Anthropomorphic Test Devices; Hybrid III Test Dummy, ES–2re Side Impact Crash Test Dummy

ACTION: Notice of proposed rulemaking (NPRM).

SUMMARY: This document proposes corrections or minor changes to some of the drawings incorporated by reference

**Figure 1: Corrections to pendulum dimensions
in Figure 22 of Section 572.33(c)(3)**

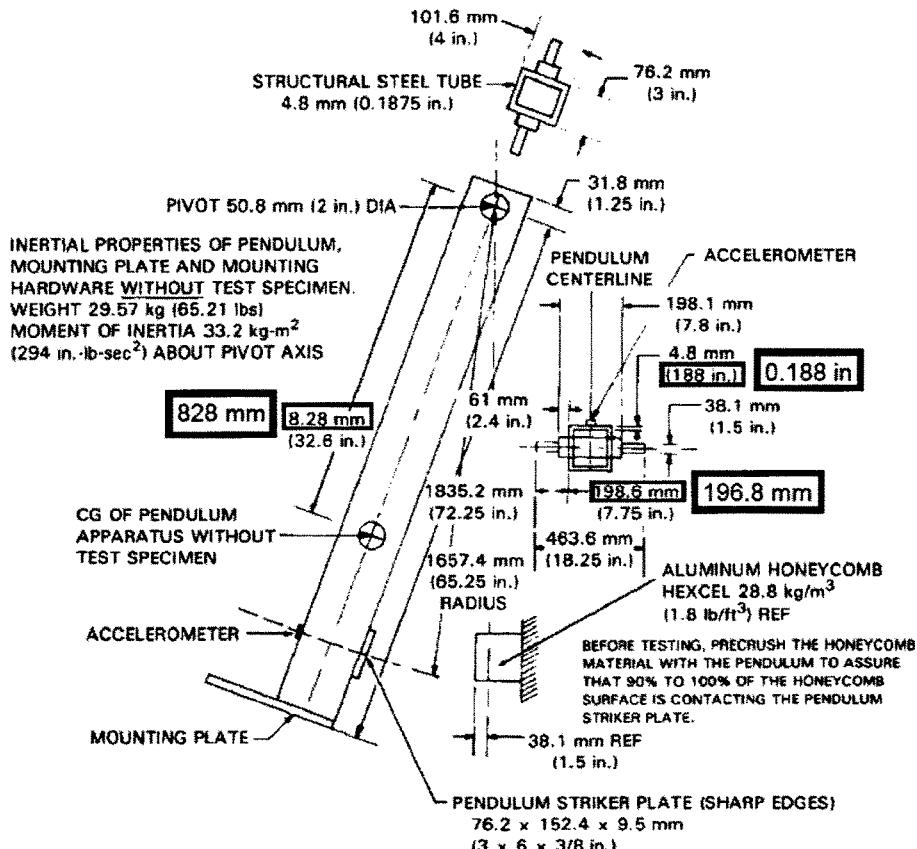
NHTSA observed that Figure 22, “Pendulum Specifications,” of 49 CFR part 572 has several dimensional errors that need correction. This pendulum is used in neck qualification tests for the ES–2re as well as other adult crash test dummies, including the Hybrid III 50th percentile male and 5th percentile female frontal crash test dummies, the SID–IIIsD 5th percentile female side impact dummy, and the SID and SID/HIII side impact crash test dummies. The dimensional corrections that should be made to this figure are listed below and shown in Figure 1 of this preamble, below:

- The 8.28 millimeter (mm) (32.6 inch (in)) dimension should be 828 mm (32.6 in);
- The 4.8 mm (188 in) dimension should be 4.8 mm (0.188 in);
- The 198.6 mm (7.75 in) dimension should be 196.8 mm (7.75 in).

FIGURE 22
PENDULUM SPECIFICATIONS

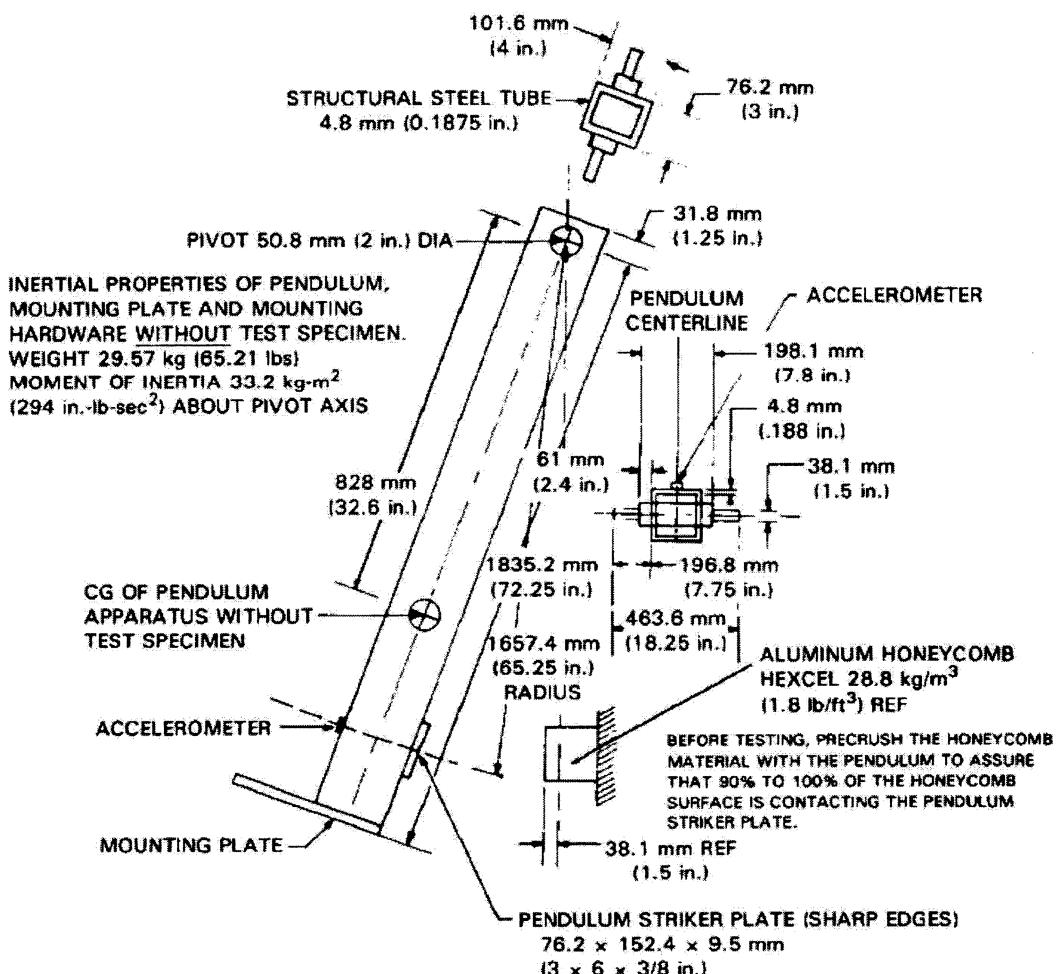
2. In § 572.33, revise Figure 22 following paragraph (c)(3) to read as follows:
